## 1968 Corvette: Service Bulletin: Refrigerant Leak

**Model and Year:** 1968 Vehicles with Air Conditioning **Source:** Chevrolet Dealer Service Technical Bulletin

**Bulletin No:** 68-T-56

**Date:** July 12, 1968

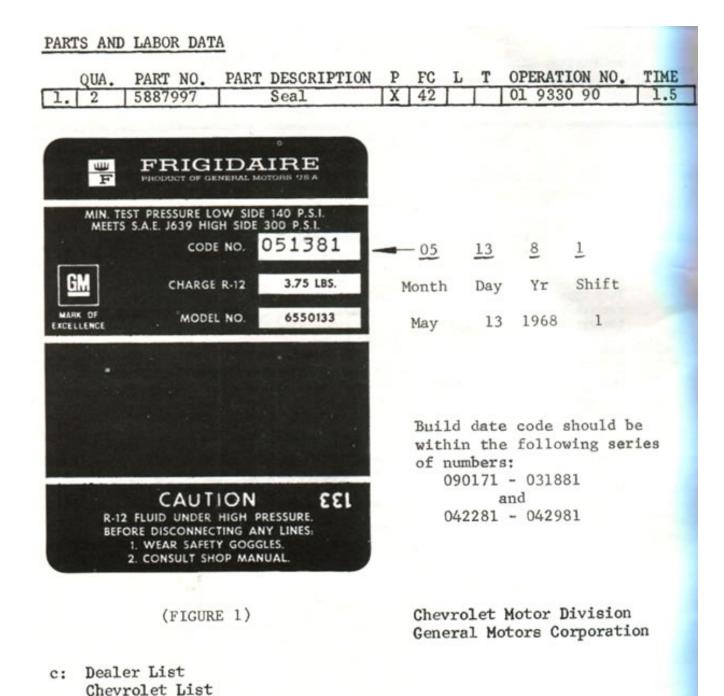
In production, the suspected seals were used between September 1, 1967 and March 18, 1968 and again between April 22, 1968 and April 29, 1968. Compressors built within these dates may be identified by noting the date stamped on the identification tag (See Fig. 1) located on top of the compressor.

- 1. Discharge the system and remove the connector block from the rear of the compressor.
- 2. Remove two (2) O-rings from exposed cavities and discard.
- 3. Install new O-rings, Part No. 5887997, and reverse Steps 1 and 2.

4. Add a dab of white paint after the shift digit on identification tag.
